Enclosed you will find a formally signed land owner petition for annexation and documents detailing the issues with CAM-PLEX Central Pavilion roof.

MEMORANDUM

SUBJECT: Central Pavilion Roof

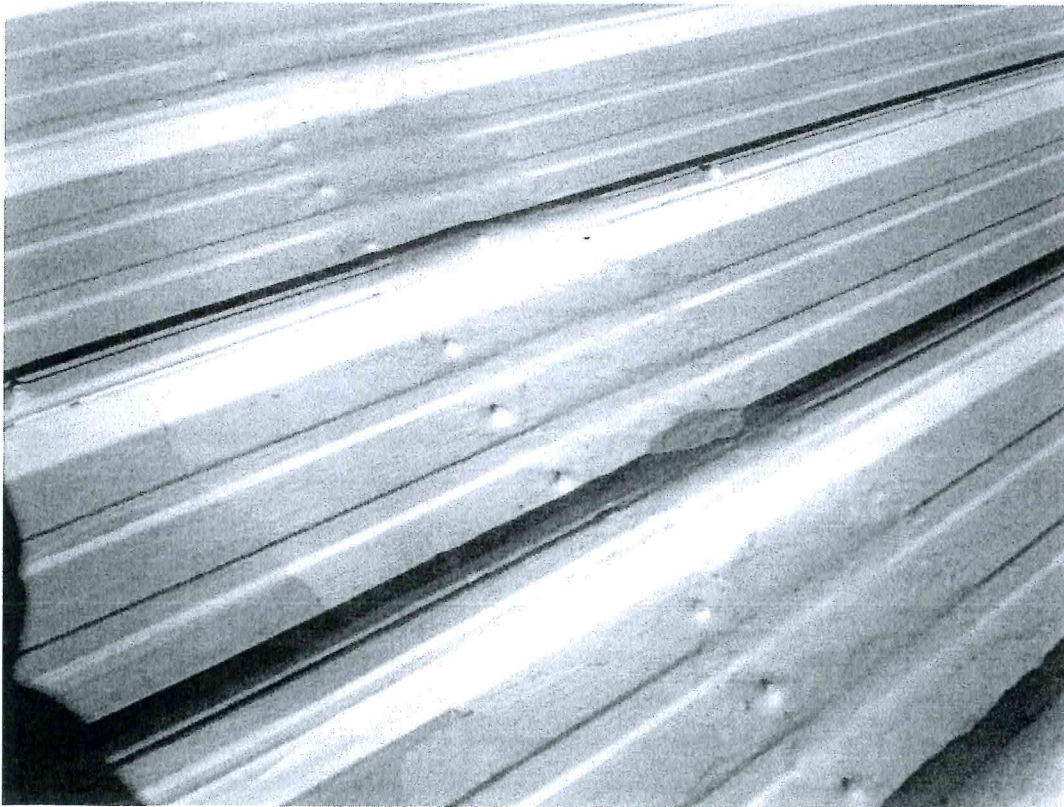
For a 15 plus year fix the roof is a good candidate for an EPDM overlay. The area between the ribs of the metal roof would be in-filled with a rigid insulation to make a level substrate. On top of the ribs and the insulation would be another layer of insulation and either OSB sheathing or a dense-dek material. To this layer and the metal roof would be a mechanically adhered EPDM roofing material. (see sketch)

Picture 1

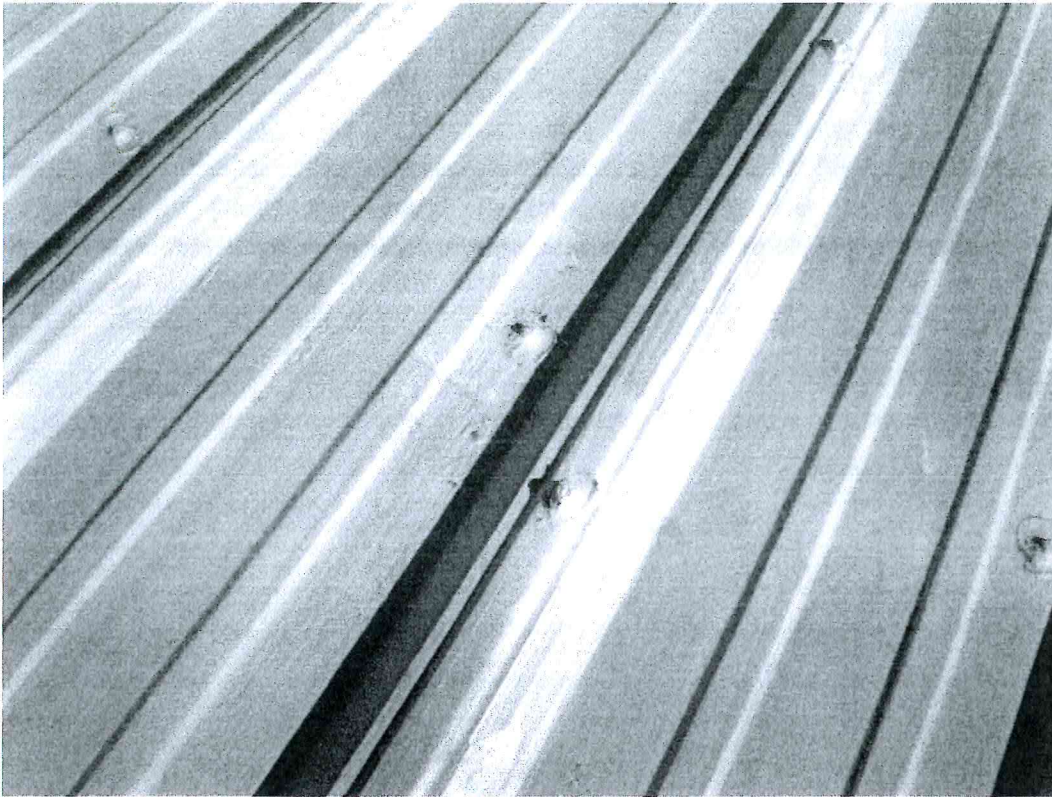
- The roof is a sheet metal roof which has been coated with an elastomeric type of roof coating. (picture 1)
- The screws which attach the metal roofing have been caulked in the past. (picture 2)
- The roof seam located at the mid-point on each side of the roof has a heavier coating of sealer on top of a tar based sealer which is failing. (picture3)
- There are large patches where the roof had been damaged in the past. (pictures 4,5 & 6)
- At the ridge cap the coating has started to flake off of the sponge sealer and the sponge material is starting to deteriorate. (picture 7)
- The metal roofing sheets are still basically sound in that there is no major rusting or movement of the metal.
- There is some rusting occurring around the roof-mounted exhaust fans. (picture 8)
